UNITED STATES PATENT AND TRADEMARK OFFICE

10/644,134

Office Action Summary

DETAILED ACTION

FIG. 6

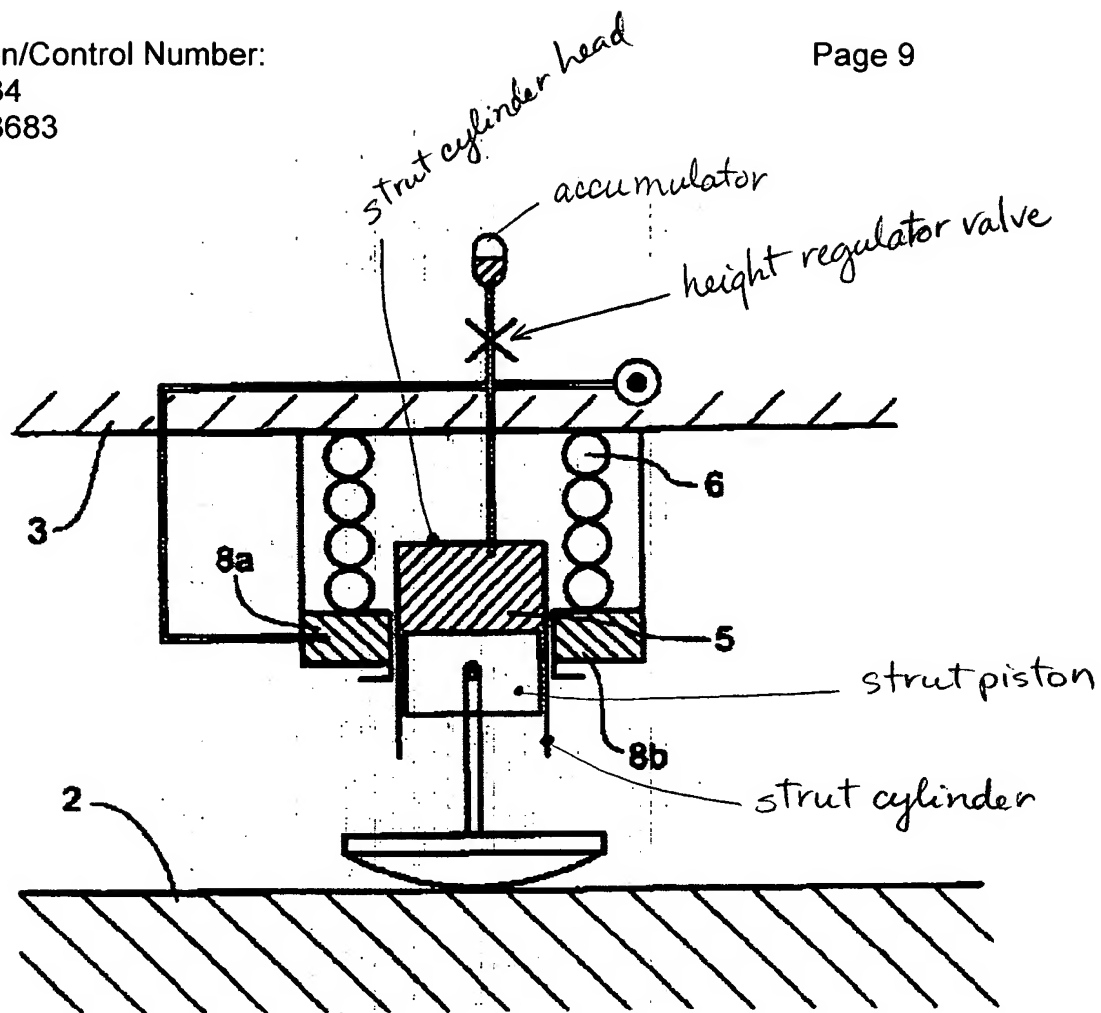
Re: claim 27, Teichmann shows a spring element in figure 6, as in the present invention, with a hydropneumatic strut to be positioned between a bogie 2 and a body 3 of a rail car, with the strut enclosing a sliding strut piston in a strut cylinder as marked below, whereby the strut piston or strut cylinder can be connected with the bogie and other of the strut piston and the strut cylinder can be connected with the body, and a cylinder piston space 5 is connected with a hydraulic accumulator as marked below, wherein the spring element comprises an auxiliary spring 6 which is concentrically arranged with the strut, encloses the strut cylinder, and is preloaded by a hydraulic cylinder 8b which is connected with the strut cylinder piston space 5.

Re: claims 1-3, Teichmann shows the hydropneumatic strut has a hydraulic height regulator valve as marked above connected with a feedback loop, by means of which the position of the piston in the cylinder can be adjusted or determined.

Re: claims 5 and 28, Teichmann shows a bore extending in a longitudinal direction of the cylinder is positioned in a cylinder head, and the mechanical feedback loop of the a height regulator valve is located in a bore extending perpendicular thereto in the cylinder head, as shown in the figure 6.

Re: claim 12, Teichmann shows a spring element in figure 6, as in the present invention, with a hydropneumatic strut to be positioned between a bogie 2 and a body 3 of a rail car, with the strut enclosing a sliding strut piston in a strut cylinder as marked above, whereby one of the strut piston or the strut cylinder can be connected with the bogie and the other of the strut piston and strut cylinder can be connected with the body, and a cylinder piston space 5 is connected with a hydraulic accumulator as marked above, wherein the hydropneumatic strut has a hydraulic height regulator valve as marked above, connected with a feedback loop, by means of which the position of the strut piston in the strut cylinder can be adjusted or determined, wherein the spring element includes an adjustment unit 8b, aligned with the strut, that can be height adjusted in the direction of movement of the strut and which is supported on the strut piston or strut cylinder, and wherein the adjustment unit includes a hydraulic cylinder piston 7b introduced into a hydraulic cylinder 7a, height-adjustable in the direction of movement of the strut, and supported on the strut piston or strut cylinder, as shown in figure 6.
